Ashburton Elementary School Addition, Mandatory Referral, MR2018009

Completed: 2/05/2018

This report consists of staff review of the Mandatory Referral for the proposed construction of two additions and one modular building on the Ashburton Elementary School site, submitted by the MCPS. The Planning Board action on a Mandatory Referral is advisory.

Figure 2: Proposed Site Plan

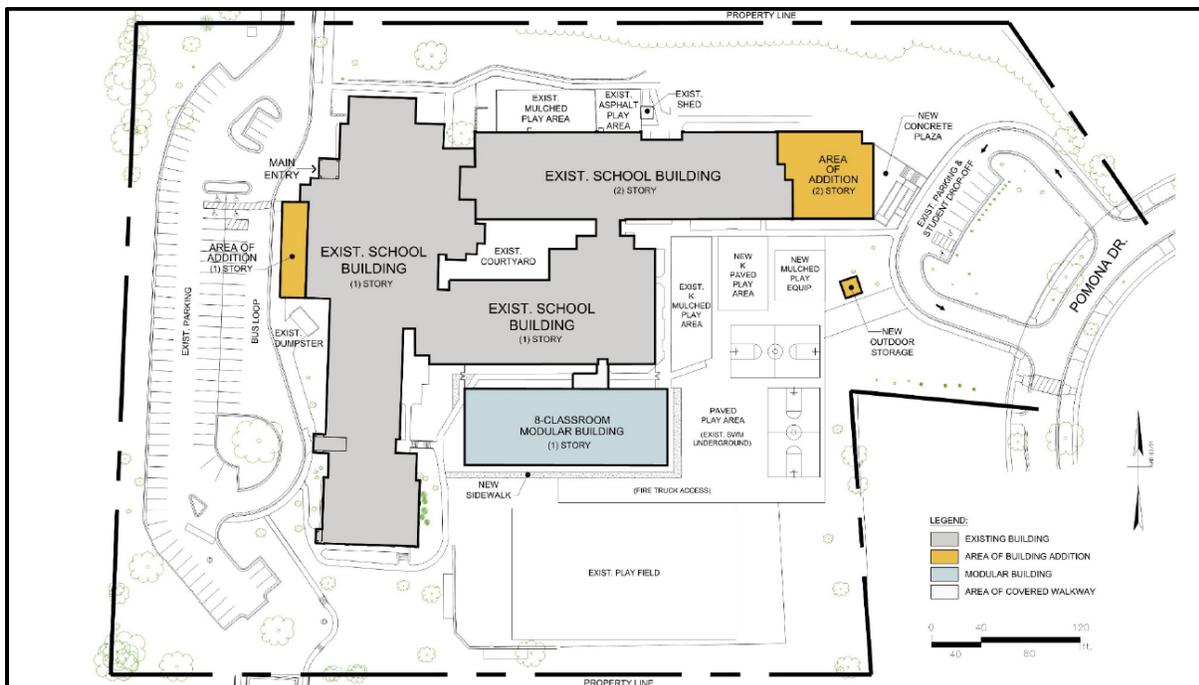
- Regrade and replant trees along the Lone Oak Drive frontage to allow for future installation of a 10-foot-wide sidepath.
- Ensure the area where the school sign is located does not conflict with the future installation of the sidepath.
